RE: Proposed Georgia-Pacific Hosford Facility - Additional Information per July 28, 2000
Conference Call

RE: March 21, 2000 Modeling Comment Letter for the Proposed Georgia-Pacific Oriented Strandboard (OSB) Facility in Hosford, FL

SUBJ: PSD Permit Application for Georgia-Pacific Corporation Oriented Strandboard (OSB)
Plant located near Hosford (Liberty County), Florida
PSD-FL-282

Re: Request for Additional Information – EPA Comments
DEP File No. 0770010-001-AC (PSD-FL-282)
Proposed Hosford OSB Plant

Figure 2-1. Location of St. Marks Wilderness Area Air Modeling Receptors

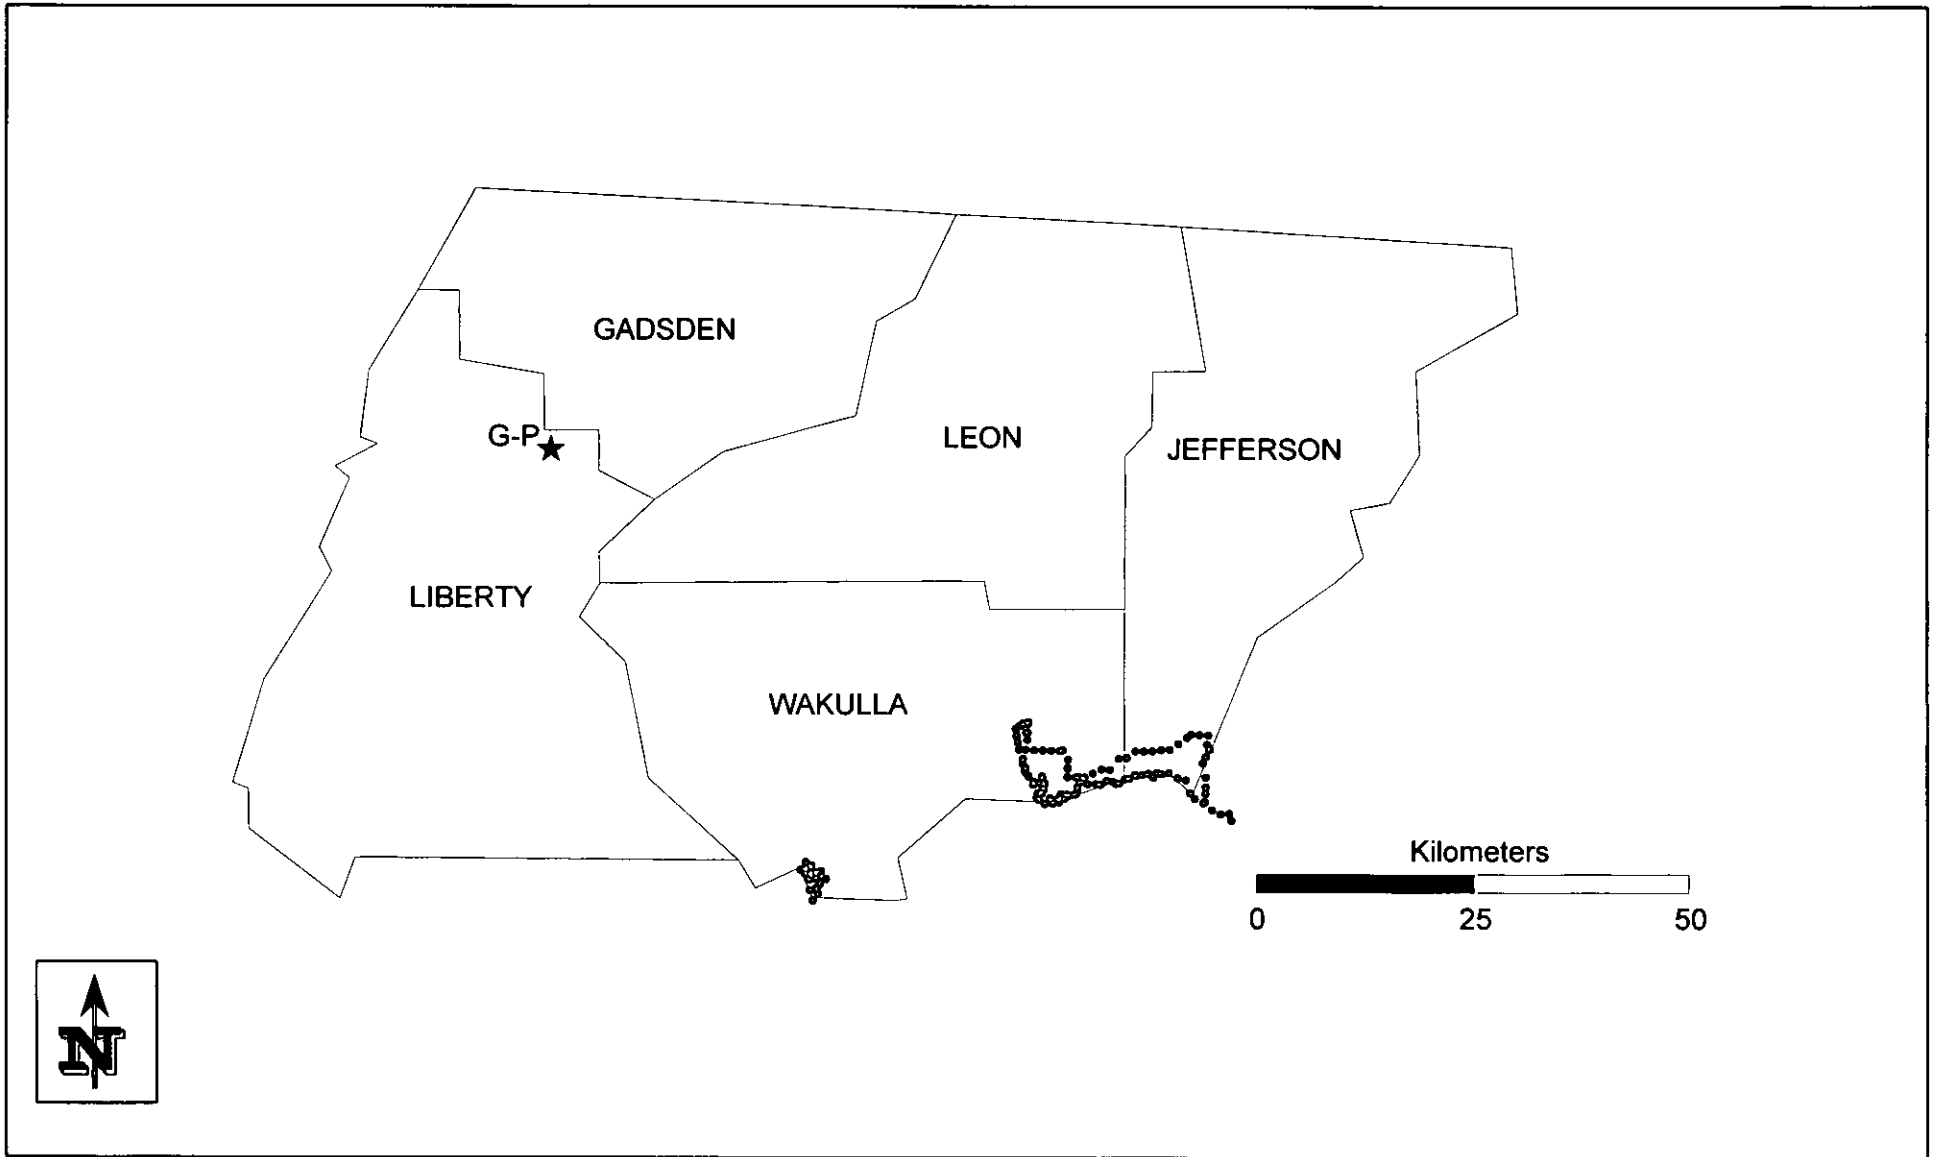
The St. Marks Wilderness Area receptor locations are shown in Figure 2-1 relative to the proposed G-P plant site location.

Figure 2-2. Location of G-P Site, Meteorological Stations, Receptors and MM4 Grid Points within CALMET Modeling Domain

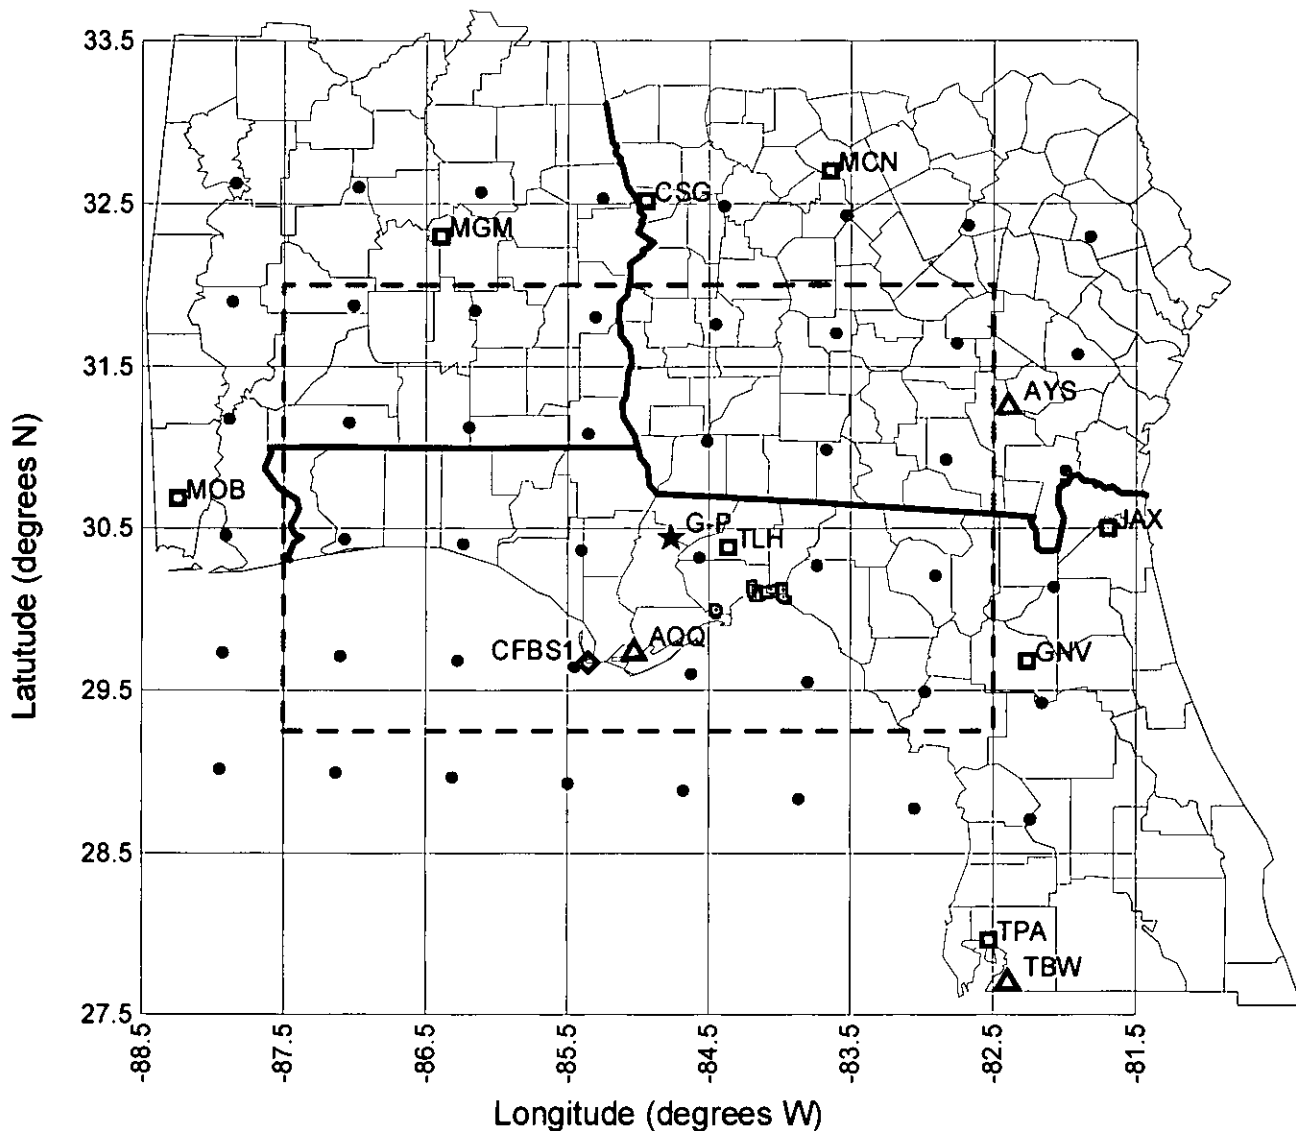
For the processing of meteorological and geophysical data, 95 grid cells were used in the x-direction and 60 grid cells were used in the y-direction. A grid resolution of 5 km was used. The air modeling analysis was performed with the UTM coordinate system. The modeling domain is outlined by the dashed orange rectangle in Figure 2-2.

A summary of the surface, over-water, and upper air stations used in the air modeling analysis is presented in Table 2-5. The locations of these weather stations are shown in Figure 2-2.

Figure 2-3. Location of Precipitation Stations within CALMET Modeling Domain

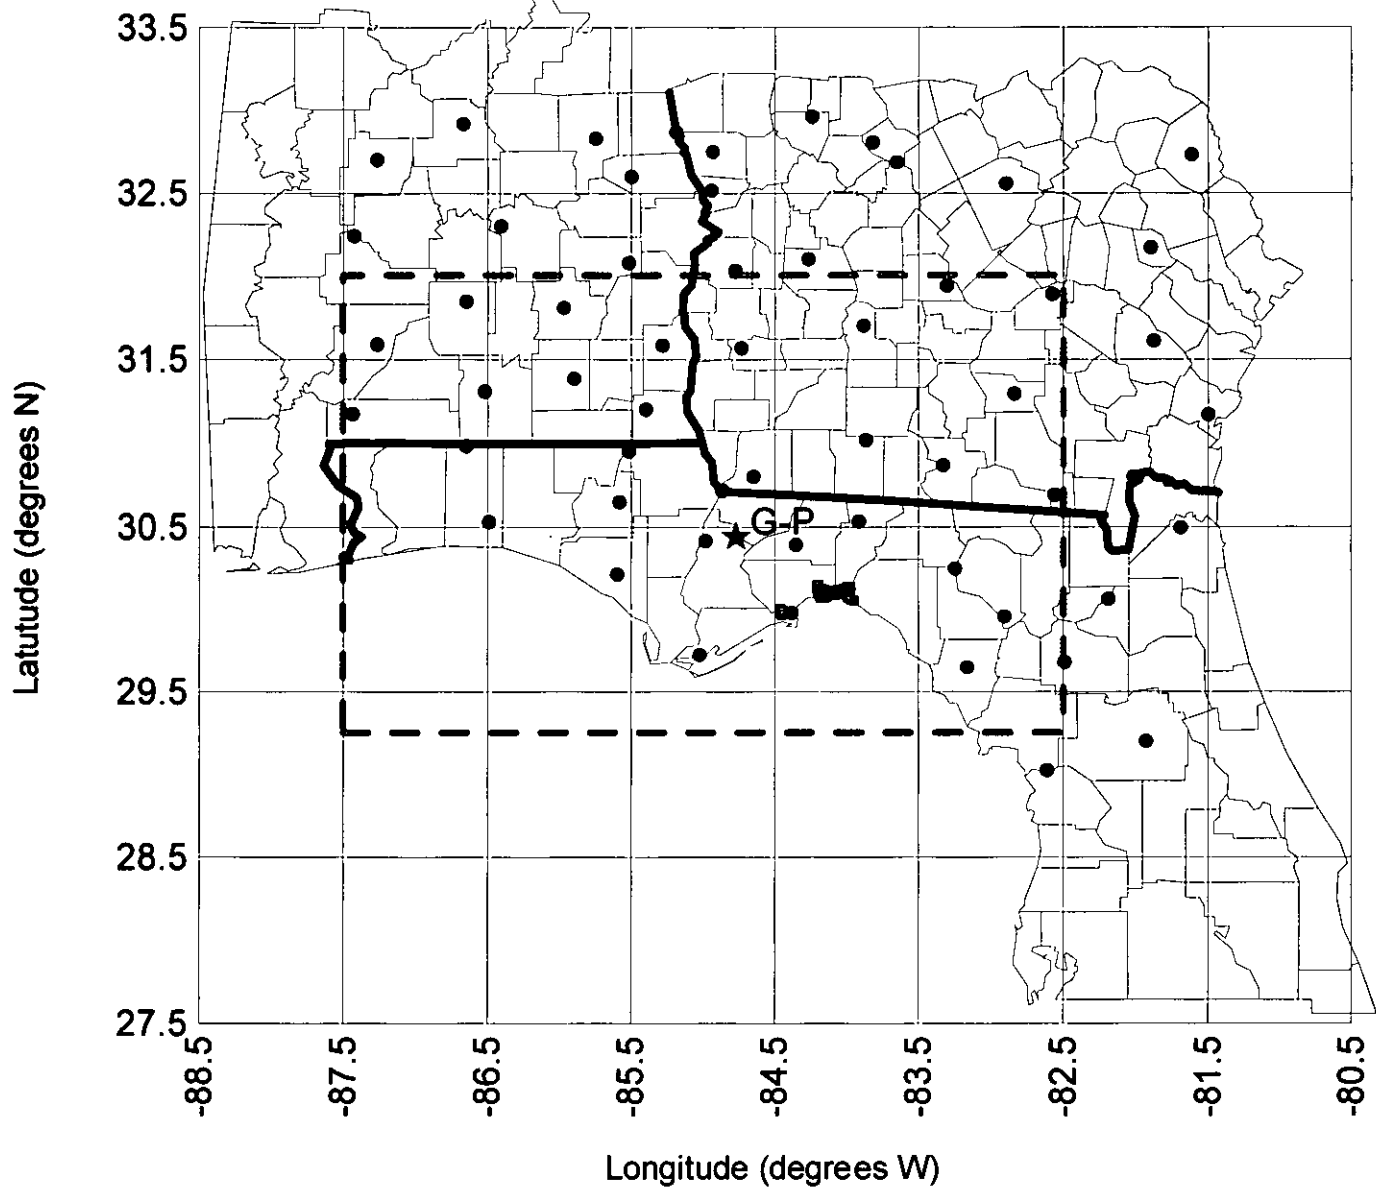
A listing of the precipitation stations used for air modeling analysis is presented in Table 2-6. Precipitation station locations are shown relative to the modeling domain in Figure 2-3.
